ADDENDUM A

TO DRAWINGS AND SPECIFICATIONS FOR:  
Furniture Bid Package: Westgate Elementary School

TACK Project #: 2023.023.00

5. AC-01:

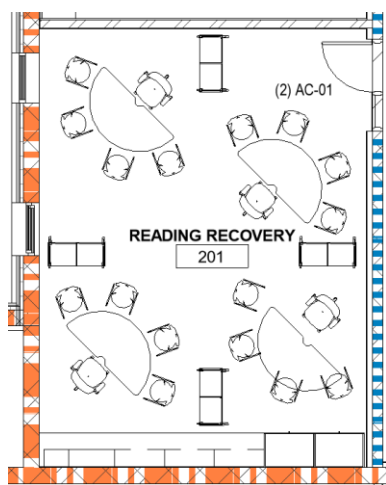
a. “Which is preferred, fabric or acoustic partitions (PET)?”

b. “What is the design intent here? Is the intent to meet the max width of 120” W or to have exactly (5) panels? Would 3-panels be acceptable to meet 120”W?”

1) *ANSWER: Material allowing ability to pin up/display printed items will be accepted.*

1) *ANSWER: The intent is to provide flexibility in isolating the half-circle tables from the rest of the group in order to enhance the student’s focus and limit distractions when needed. Space in the room is limited. The 120” length with 360-degree hinges and multiple panels allows flexibility to manipulate the shape into L-shape, C-shape, etc.*

**ID TAG:** D-01

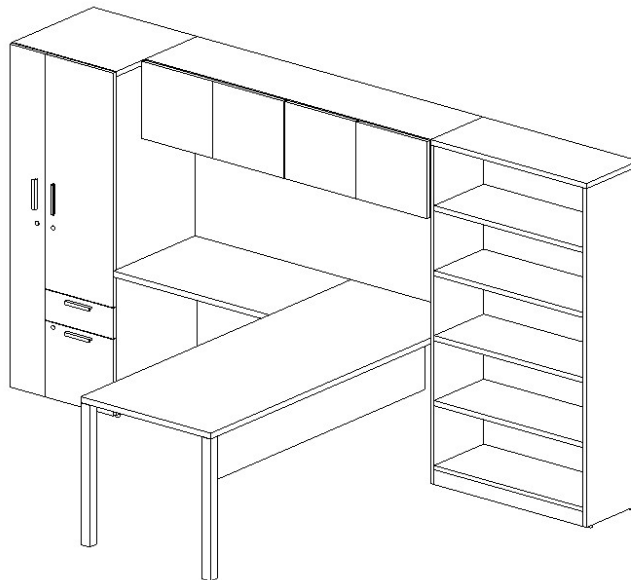
- a. *ANSWER: The quantities on CH-08 and CH-20 have been modified to meet the minimum threshold. See updated specification sheets.*
13. D-01:
- a. "For the overhead do you want this as a wall mounted unit or hutch?"

- 1) *ANSWER: Wall-mounted; the walls are 6" metal stud, framing at 16" on center, with 1 layer of 5/8" gypsum wall board.*
- b. "Is a tasklight needed under the overhead?"

- 1) *ANSWER: No.*
- c. Is a combined length of 66" acceptable for the overhead, (if wall mounted unit, 30" over main desk, 36" over return)?
- 1) *ANSWER: Yes.*

b. "Grommet locations are not included in the specification. Can you clarify grommet locations, if any?"

- 18. CH-08
  - a. Revise quantity to 6.
- 19. CH-20
  - a. Revise quantity to 6 and locations.
- 20. D-01
  - a. Description revised to include size of worksurfaces. This expresses the overall desk worksurface footprint. Please configure length of return vs. main surface per manufacturer's standards.

a) *D-01: 1 center grommet on the return surface and 1 grommet in the corner closest to the wall on the main surface. This creates 2 grommets along the length of the wall. See image example below.*

**DESCRIPTION:** L-shape high-pressure laminate desk with attached laminate, 60"W floating modesty panel, laminate storage, and metal "open" end legs/support with glides. 30"D x 78" main surface, 24"D x 36" return surface. 66"W hinge door overhead cabinet with full height tackboard below, 66"Hx24"D tower with tall closet and box/file or box/box/file, and 36"Wx16"Hx66"H bookcase. Include pull-out pencil drawer under worksurface. Include stiffeners and all components necessary to install freestanding desk. Tops to be approximately 1 1/8" thick.
